PROJECT :	BHADRADRI THERMAL POWER STATION 4 X 270 MW, UNITS-1 TO 4, MANUGURU, TELANGANA, INDIA
-----------	---

TITLE :	TOTAL SHEETS	0
	GA AND LOAD DATA OF BCN-1A/B	SHEET

COMPLIANCE TO COMMENTS OF DESEIN

ON GA DRAWINGS OF BC-1A&B R1 SUBMITTED BY BHEL FOR APPROVAL

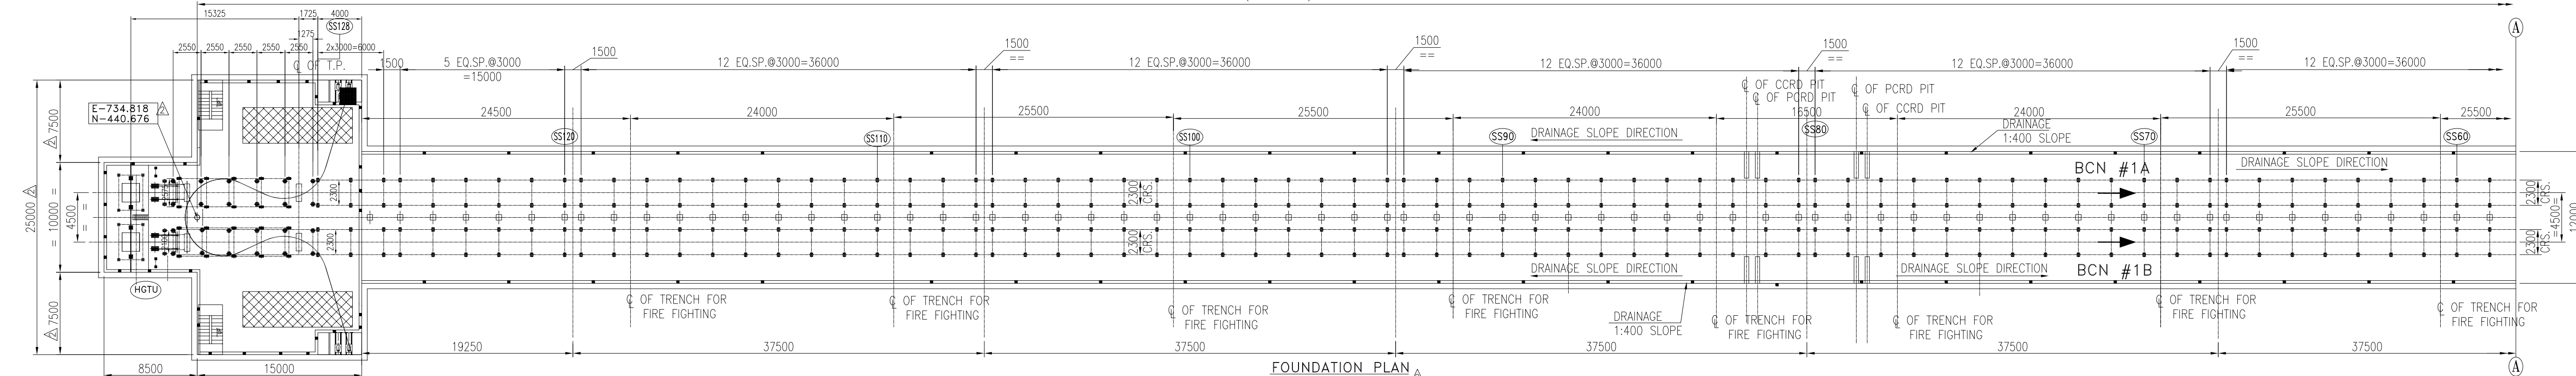
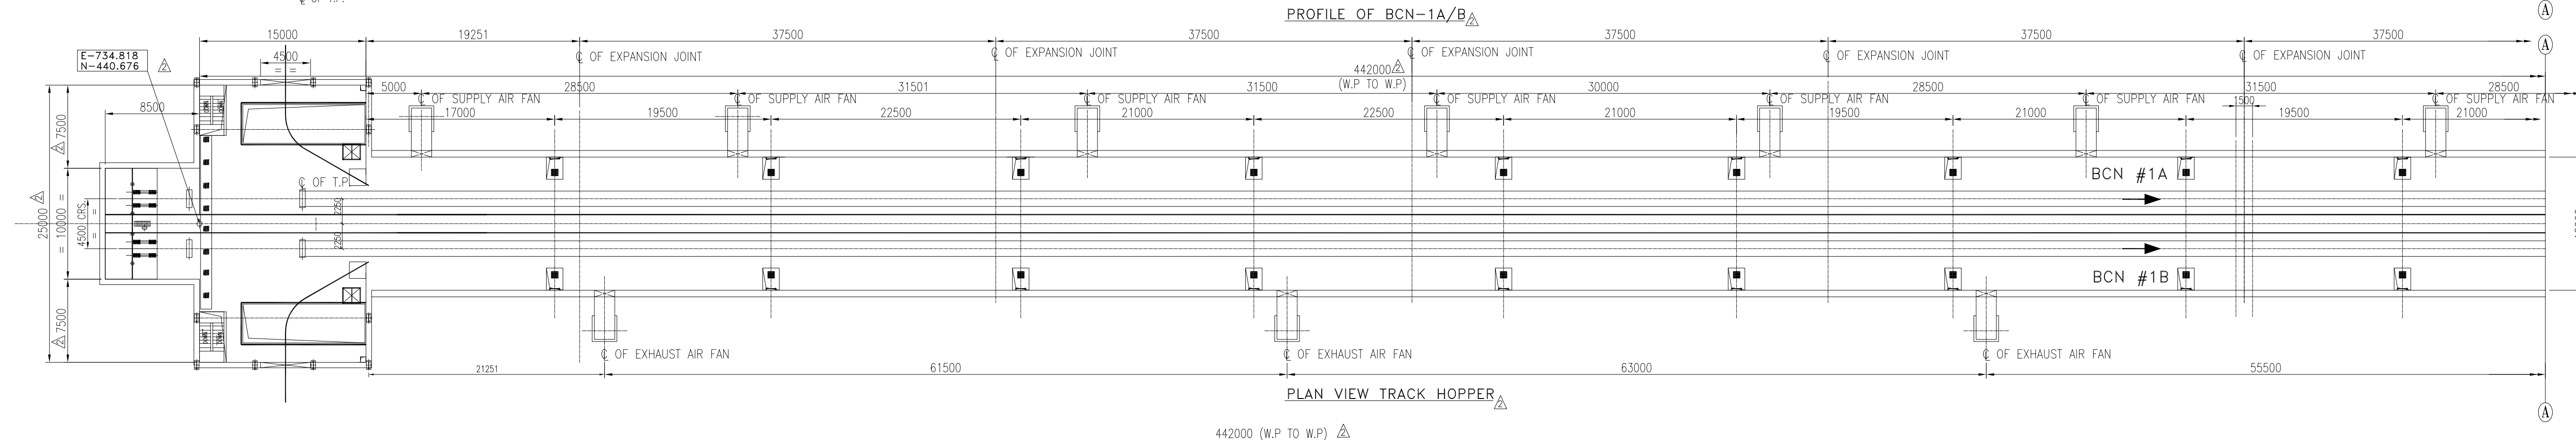
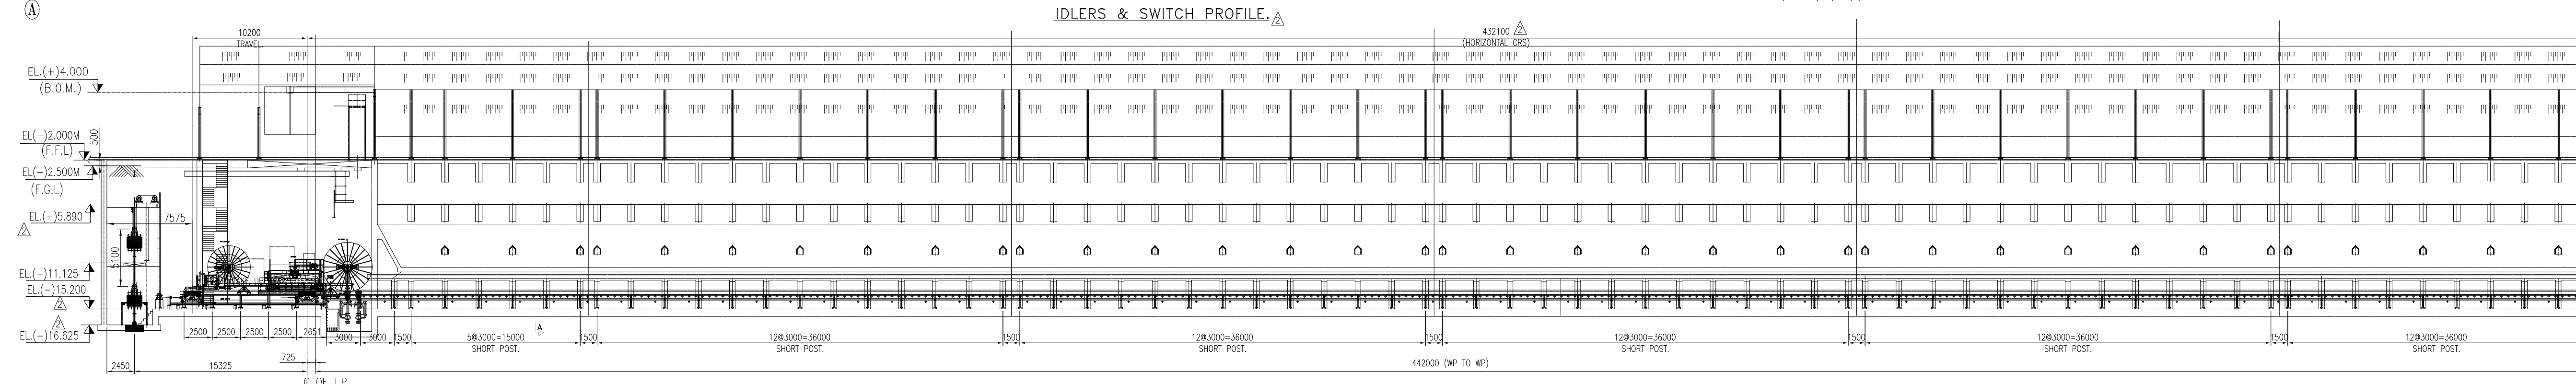
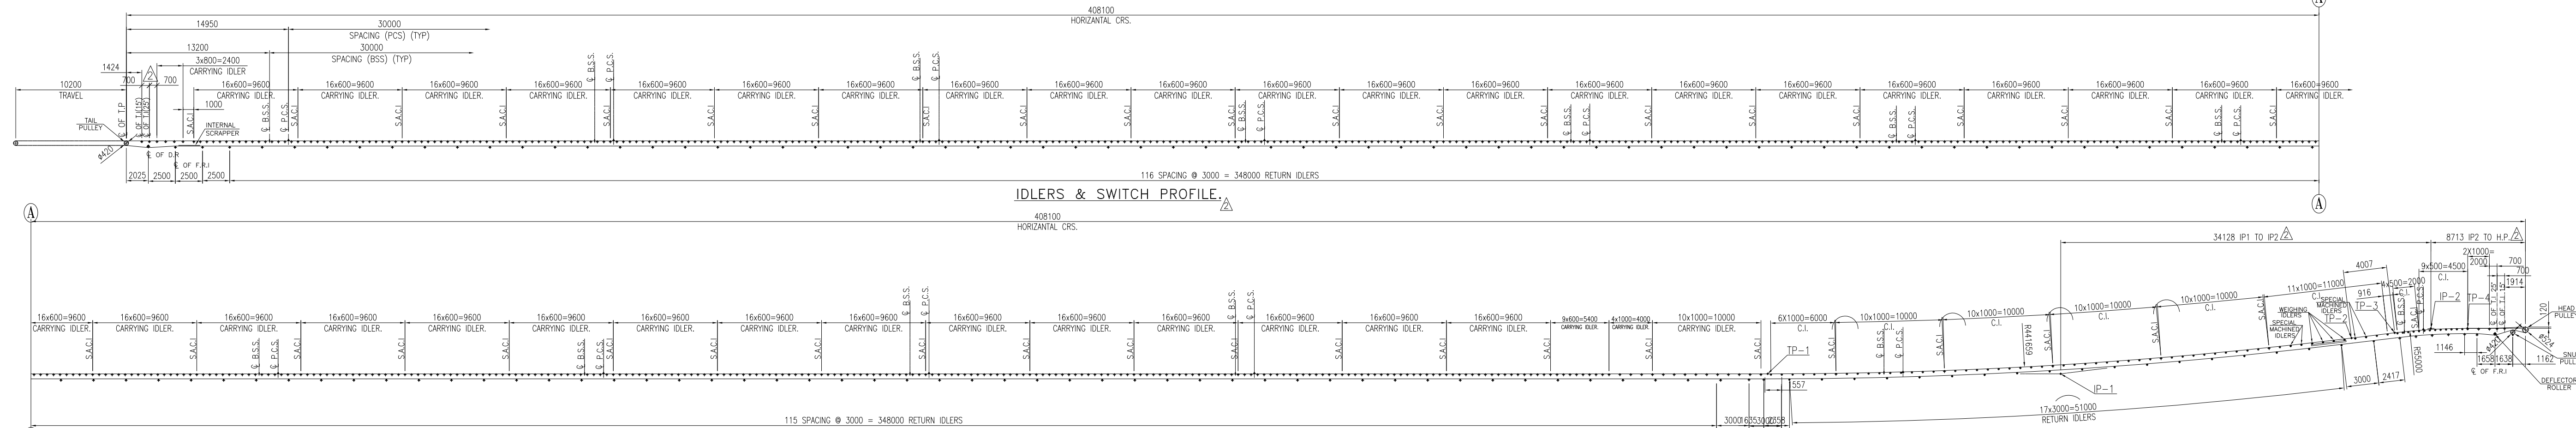
Ref:	Comments made on GA Drawing prints of BC-1A&B, R1 by DESEIN		
SL NO	DESEIN COMMENTS.	COMPLIANCE / CLARIFICATIONS BY BHEL	REMARKS
1	Please indicate the angle of north orientation	Indicated	
2	Please indicate dead and live load for short posts	Indicated	
3	Please provide ventilation system with shed for maintenance of ventilation fan along with handling equipment	Canopy shall be provided.	
4	Please complete the full data in technical specification and provided counter weight details	Updated.	
5	Please confirm the *marked data and delete note 6.	Updated.	
6	Please provide access platform for skirt board	Skirt board will be attached to paddle feeder machine. Ref. GA of Paddle Feeder for further details.	
7	Drawing shall be revised considering track hopper for unloading complete rake.	Drawing is been revised for double track hopper, as per ERM.	
8	Refer enlarge details of head frame, please indicate the chute opening size.	Chute opening size indicated

9	Please provide belt weigher and add a section for the same	Indicated	
10	Distance between transition idler shall be 700mm. Please correct	Corrected	
11	Refer base plate details for SS129 to 144: please indicate channel size.	Channel size indicated
